AEBS-11 – Industry Input

AEBS-11 – Car 2 Bicycle provisions

Industry proposal for bicyclist deceleration to be taken into account for AEB C2B performance:

Deceleration of the AEBS vehicle for speed reduction computation in Car2Bicycle scenarios

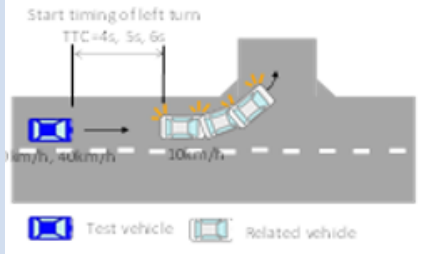
- Scope of this Regulation is M1 and N1 vehicles
- Especially, but not only, not all N1 vehicles will be able to achieve a deceleration of 9m/s^2 , even more so when the vehicle is at its maximum load
- For the Car2Bicycle scenario, compensation of a lower deceleration might not be possible, e.g. like braking earlier, because this would likely increase false positives.
